CPED STAFF REPORT
Prepared for the City Planning Commission

CPC Agenda Item #6
September 29, 2014
BZZ-6760

Property Location: 3101, 3101 ½, 3117, 3121, 3123, and 3127 Lake Street East
Project Name: Walgreens
Prepared By: [Lisa Steiner](#), City Planner, (612) 673-3950
Applicant: Semper Development
Project Contact: John Kohler
Request: To allow a new 15,780 square foot Walgreens retail store with drive-through pharmacy.

1 SITE PLAN
1" = 20'

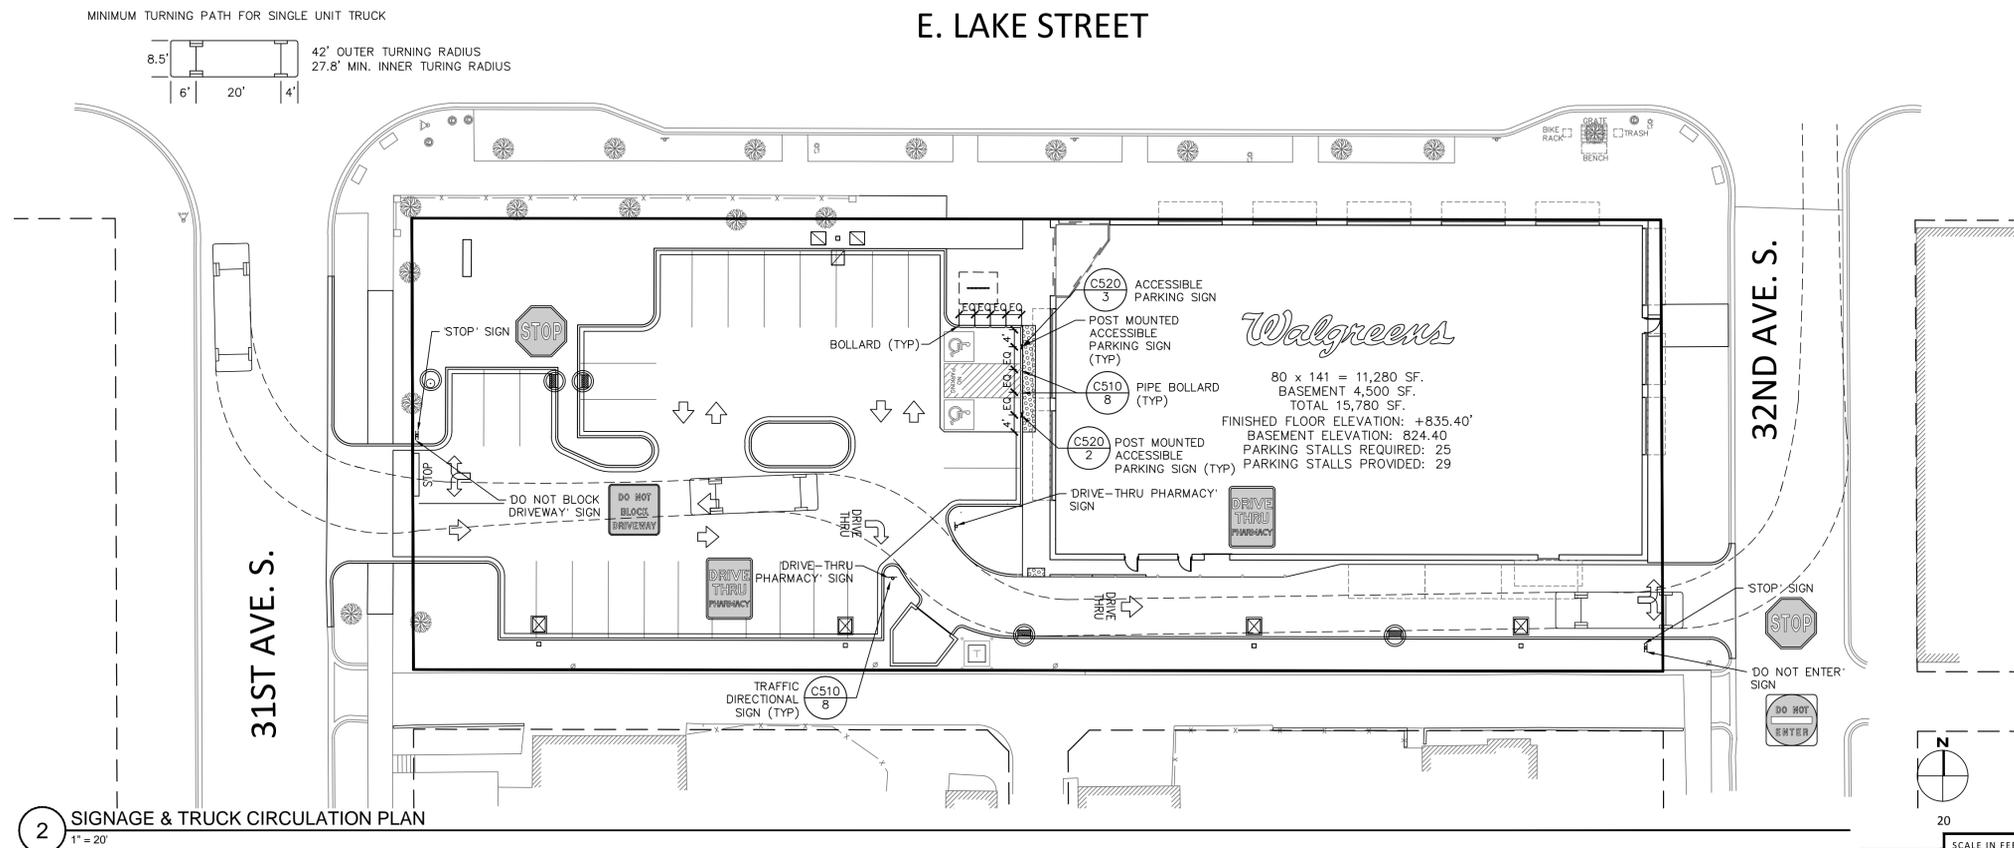
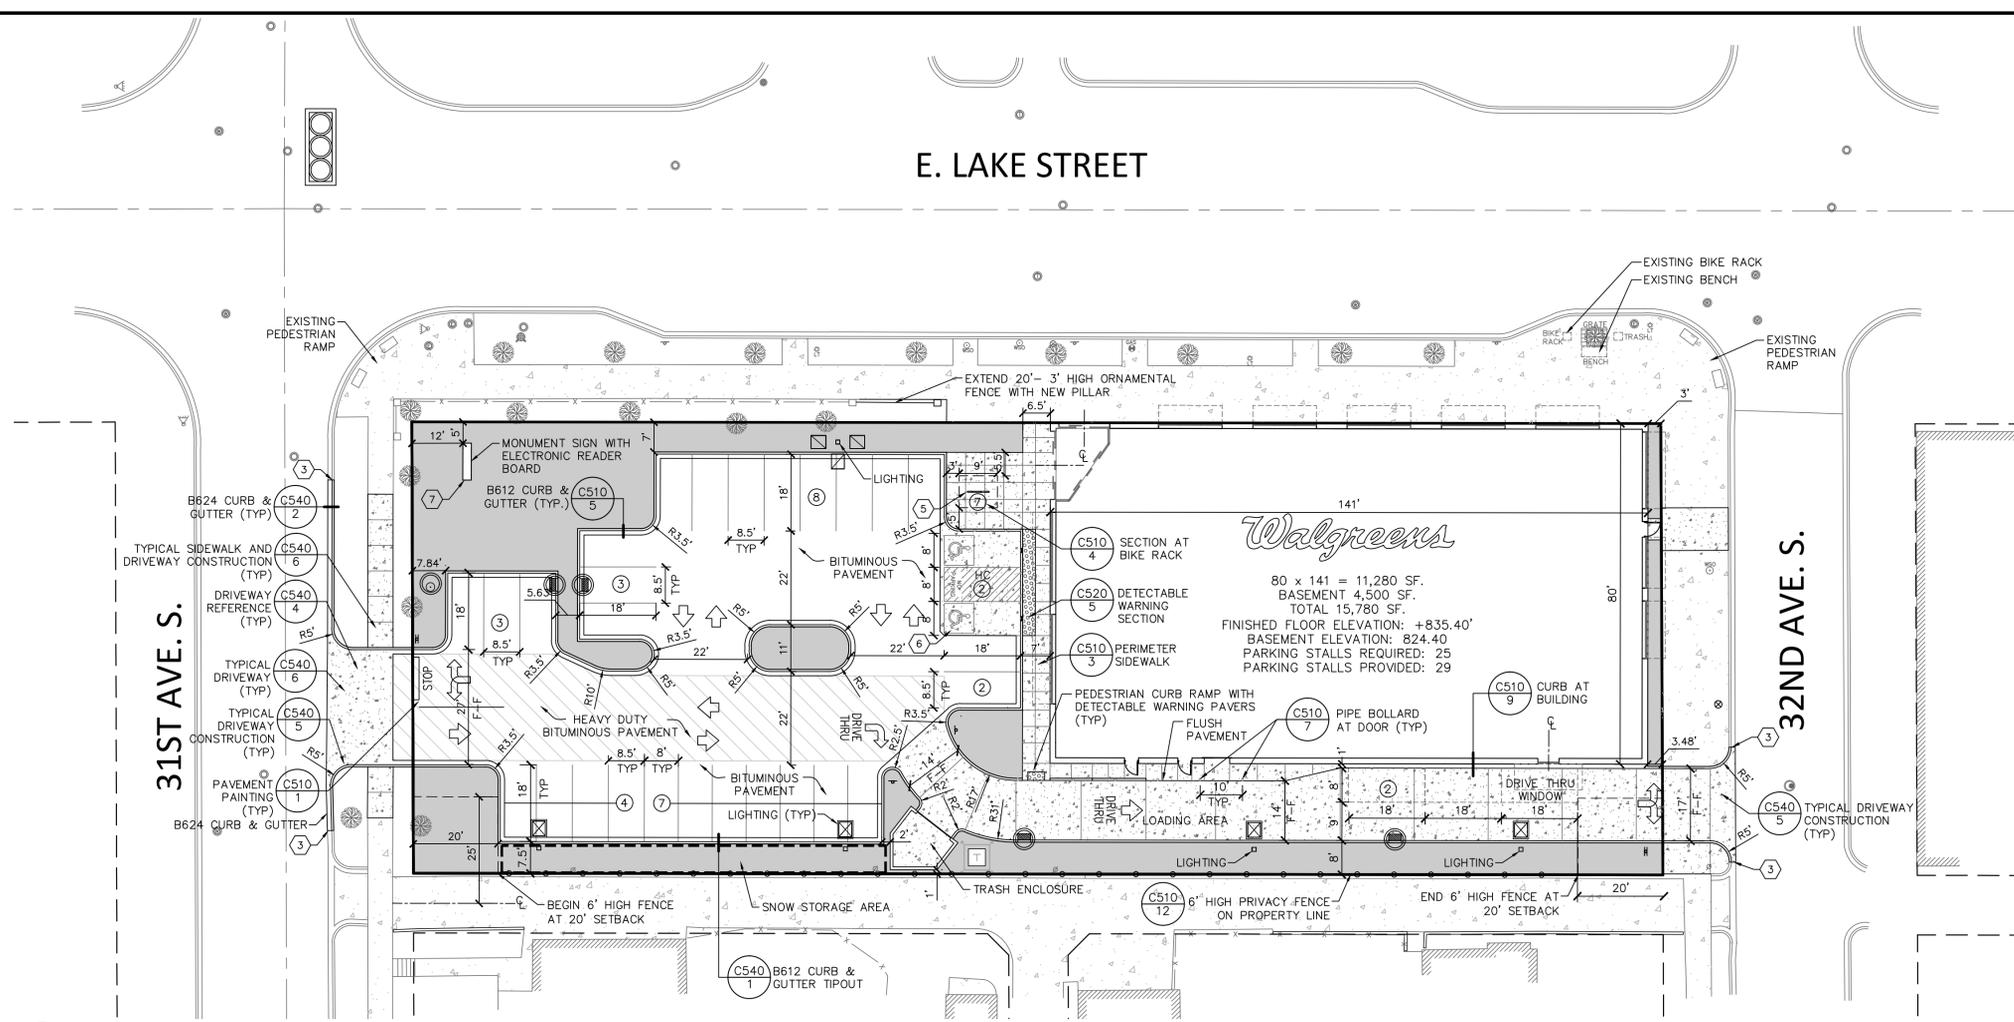
- The vehicular access and circulation has not been designed to minimize conflicts. The three parking spaces located directly north of the curb cut on 31st Avenue may cause conflicts with cars exiting or entering the site as their drive aisle overlaps with the only entrance into the site and the only exit for patrons of the store who are not utilizing the drive-through. Any queuing for exiting the store would interfere with maneuvering for these three spaces. Additionally, staff expects that snow plowing would prove difficult with the configuration proposed in this area. Staff believes that it would be reasonable to redesign the parking lot to eliminate these three parking spaces, thereby improving vehicular maneuvering through the site, reducing impervious surface, and further anchoring this corner of the site with contiguous landscaping. Staff is recommending that the applicant consider eliminating these 3 spaces and replacing them with additional landscaped area.

- In general, the composition and location of landscaped areas complement the scale of the development and its surroundings.
- The applicant is exceeding the general landscaping and screening requirement that 20% of the site not occupied by buildings be landscaped and is providing 30% landscaping. See **Table 2**. Also, 8 canopy trees and 40 shrubs are required. The applicant is providing 161 shrubs total, though 96 of those are on-site and the remainder are located outside of the property line. The applicant is proposing to install 10 new trees, though only 3 of these trees would be canopy trees and the 7 others would be understory trees which will grow to approximately 20 feet in height. The applicant has indicated that the understory trees are proposed due to the location of an overhanging power line along the alley. Alternative compliance is necessary for this standard.

- Screening of the parking area is required along the north, west, and south property lines.
- Screening along the alley, which is across from residential uses, is required to be 6 feet high and 95 percent opaque. However, in the required front yards along 31st and 32nd, screening is required to be 3 feet high for the first 20 feet. The proposal is only partially meeting the requirements by providing a 6 foot high privacy fence which ends 20 feet from the east and west property lines. At the west end of the alley, the applicant is proposing juniper bushes which would screen the first 4 feet of the parking area, but the remaining 16 feet of the front yard along 31st would not have screening other than some perennials in the landscaped yard. On 32nd Avenue, about 15 feet of screening is provided, but 5 feet of perennials are proposed closest to the east property line instead of screening which meets the requirements. Alternative compliance is required for this standard.

- Along the north property line along Lake Street, a 7 foot wide landscaped yard and a screen 3 feet high and 60 percent opaque is required. Also, 6 canopy trees are required based on the linear frontage of the parking area. The applicant is proposing to install a variety of shrubs and perennials which meet the requirements, mostly outside of the property line adjacent to the public sidewalk along Lake. Four existing trees and a decorative metal fence (installed when Lake Street was reconstructed) are already located in this area, both inside and outside of the property line, as well as 3 existing boulevard trees. Alternative compliance is required for this standard.

- Based on discussions with the Director of Traffic, the parking lot access point to E Lake St. will not be allowed; the level of conflict directly resulting from this access point are not deemed acceptable, including loss of parking, pedestrian impacts, and the adjacency to McDonald's access across E. Lake St. were all considered in this discussion. The Applicant shall remove the vehicle access point from all associated plan sheets.

8. The applicant is encouraged to consider redesigning the parking area to eliminate the three spaces directly north of the curb cut on 31st Avenue South and replace those spaces with additional landscaping.

1 LANDSCAPE PLAN
1" = 20'

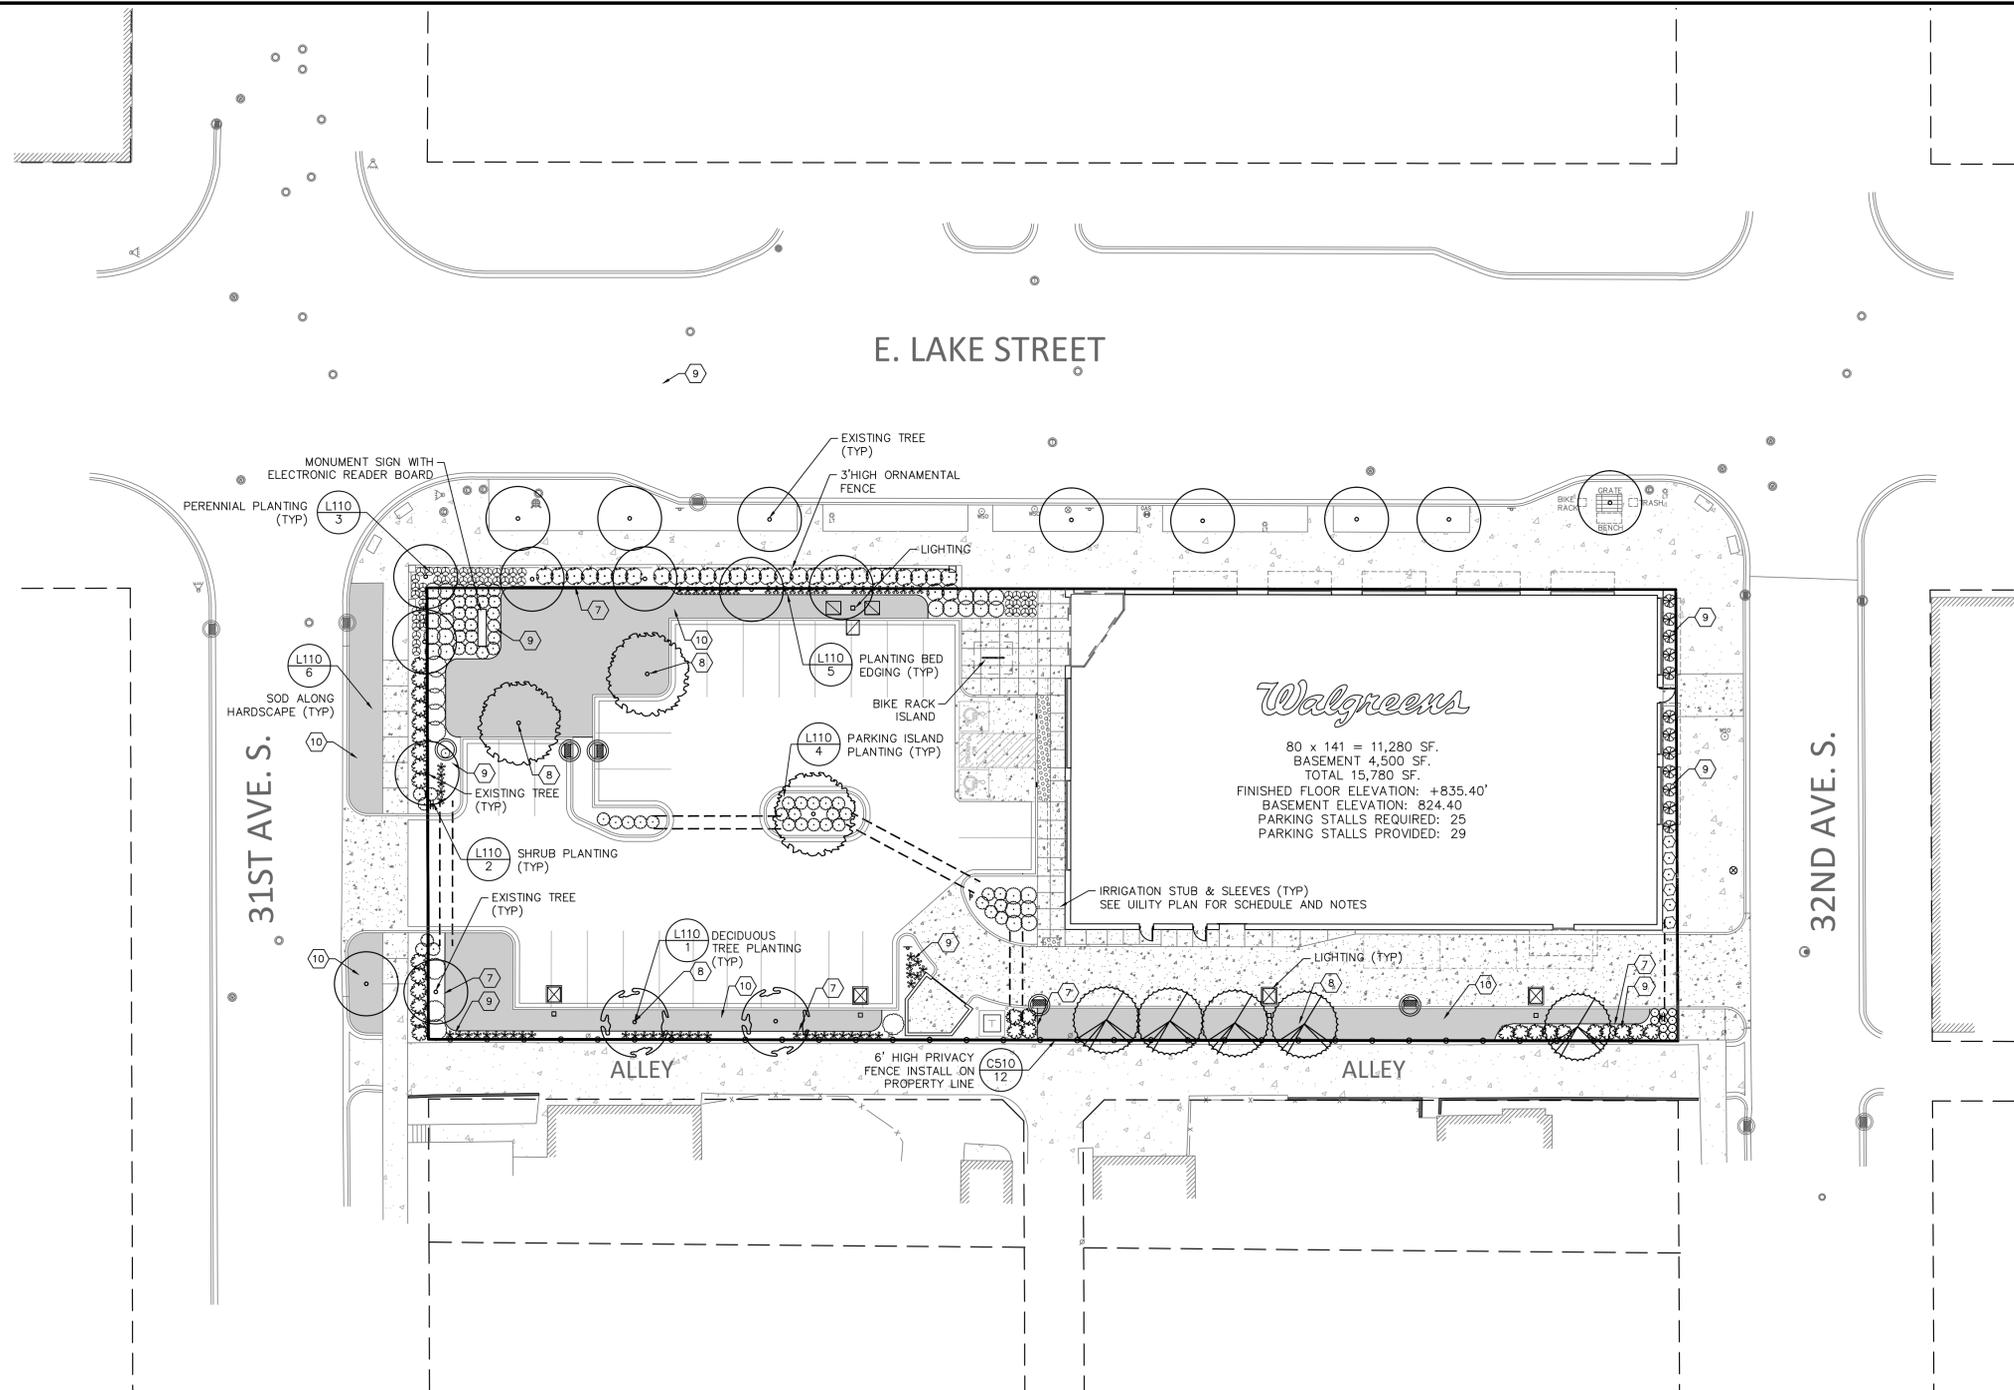
- Required landscaped yards are required to be landscaped with not less than 1 canopy tree for each 500 square feet and not less than 1 shrub for each 100 square feet. With the exception of the trees (discussed below in the screening section), the west and north required yards are meeting their requirements. However, the south landscaped yard is not meeting its requirement of 5 canopy trees and 21 shrubs. The applicant is proposing 7 understory trees and 17 shrubs in the required south yard. Alternative compliance is required.

- **General landscaping standard of one canopy tree for each 500 square feet of required landscaping.** 3,991 square feet of landscaping is required for this site, including 8 canopy trees. The applicant is proposing to provide 10 on-site trees, though only 3 trees would meet the definition of a canopy tree. Canopy trees are deciduous trees which commonly grow to at least 35 feet at maturity. The applicant is, however, proposing to provide 7 "understory" deciduous trees which would grow to 20 feet at maturity. The applicant has indicated that this is necessary due to the location of overhead power lines along the alley. There are 8 existing trees that are currently located on or slightly outside of the property line along Lake and 31st which would remain with the proposed development, bringing the total number of trees to 18, as well as 8 trees in the boulevard which would remain along Lake Street and 31st. Staff finds that the applicant's proposed alternative meets the intent of the chapter and that the existing trees on site and in the public right-of-way mitigate any adverse effects of the alternative. Staff recommends that the Planning Commission grant alternative compliance for this standard.

- **Number of canopy trees and shrubs in required south landscaped yard.** Along the southern property line, the required landscaped yard is required to be landscaped with not less than 1 canopy tree for each 500 square feet and not less than 1 shrub for each 100 square feet. The south landscaped yard would have a requirement of 5 canopy trees and 21 shrubs. The applicant is proposing 7 understory trees and 17 shrubs in the required south yard. As recommended above, staff finds that the understory trees are a suitable alternative. However, staff is recommending that the Planning Commission not grant alternative compliance for the reduced number of shrubs and instead has recommended a condition of approval that at least 4 additional shrubs be provided in the south required landscaped yard.

- **Landscaping and screening of parking fronting a public street tree requirement on Lake Street.** Along the north property line along Lake Street, 6 canopy trees are required. The applicant is not proposing to install any on-site canopy trees along this frontage. A variety of shrubs and perennials mostly planted outside of the property line adjacent to the public sidewalk are proposed. Four existing trees and a decorative metal fence (installed when Lake Street was reconstructed) are already located in this area, as well as 3 trees in the boulevard. Additionally, the applicant is proposing an approximately 1,600 square foot landscaped area in the northwest corner of the site which would also include 2 canopy trees. Staff finds that the alternative combination of the existing and proposed trees meets the intent of the ordinance and recommends that the Planning Commission grant alternative compliance for this standard.
